EM_MSN_BRD_2_wt_module v110
not saved!
Sheet: 3/5

Magnetometer

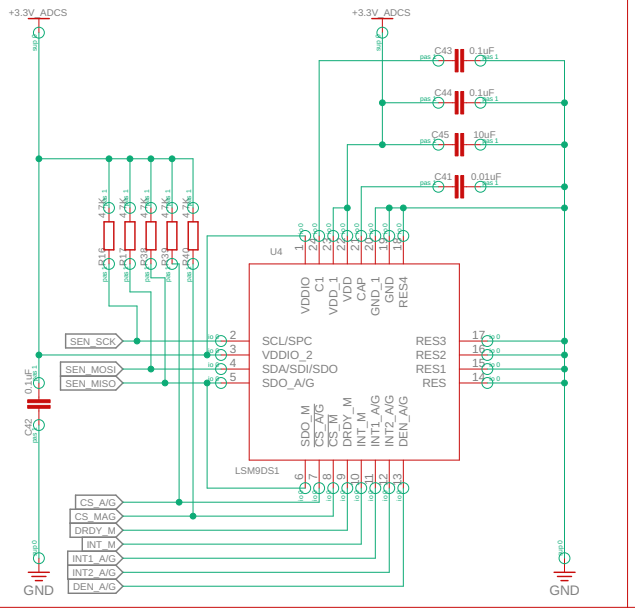
Decoupling capacitors C42, C44, C45 should be placed near to supply pin

MPU6500

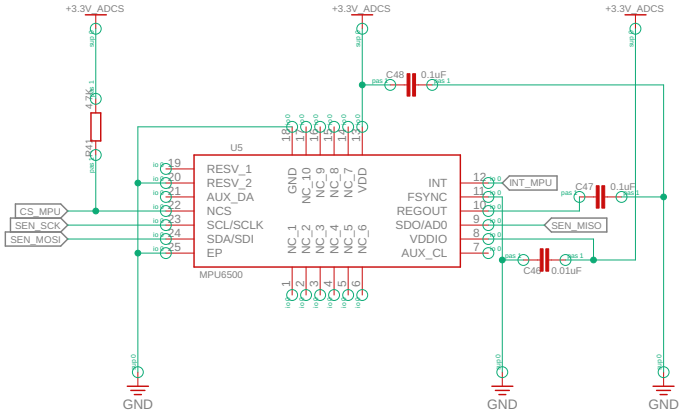
C46, C48 are Bypass capacitor
C47 is filter capacitor

USB

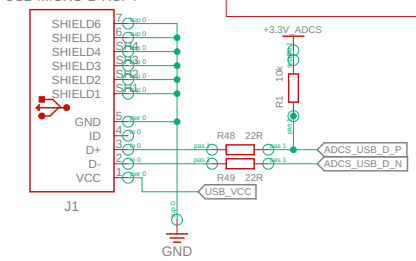
Differential pair lengths should be equal

MCU

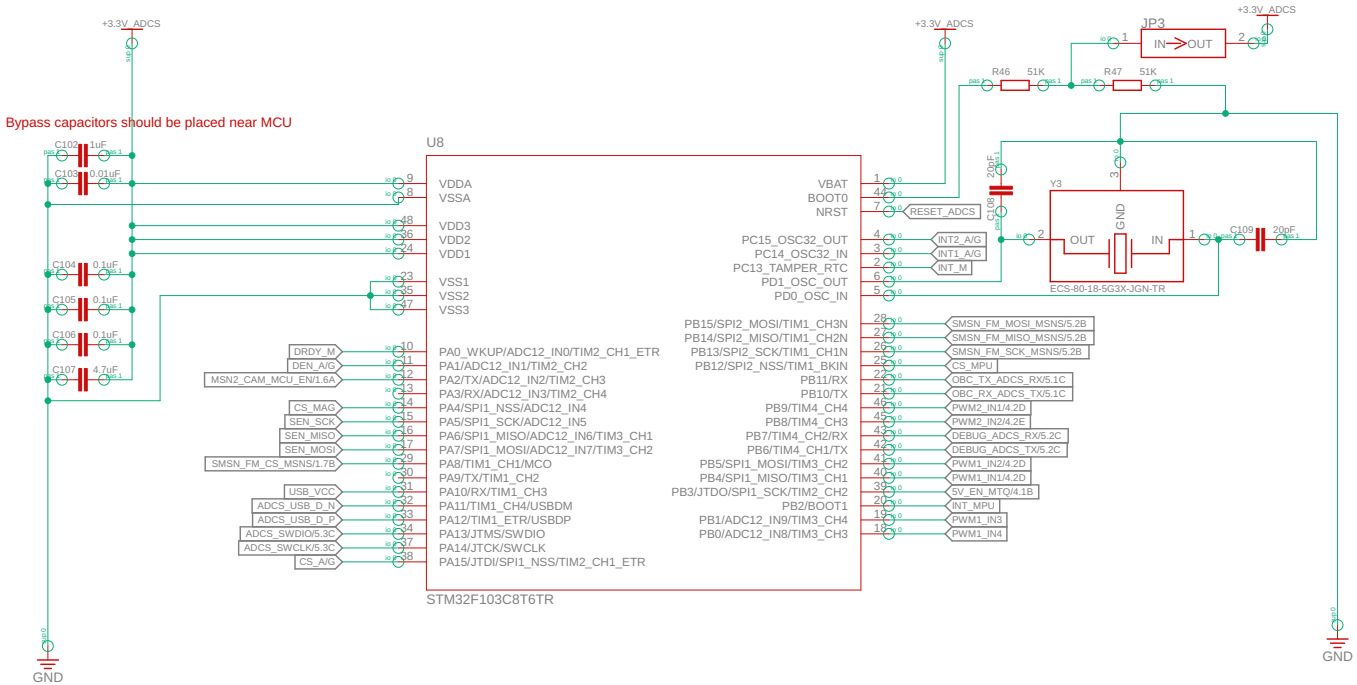
Bypass capacitors should be placed near MCU

50_Pin_Connector

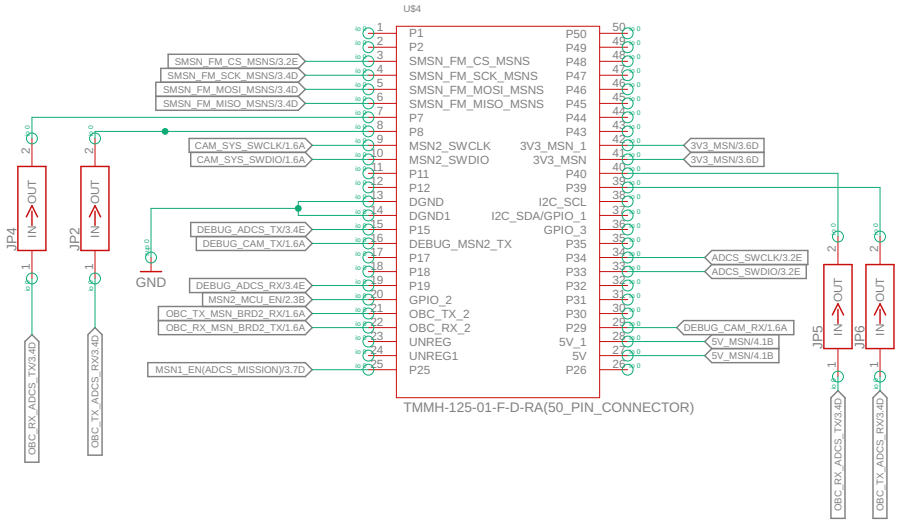
camera switches. Not needed in ADCS
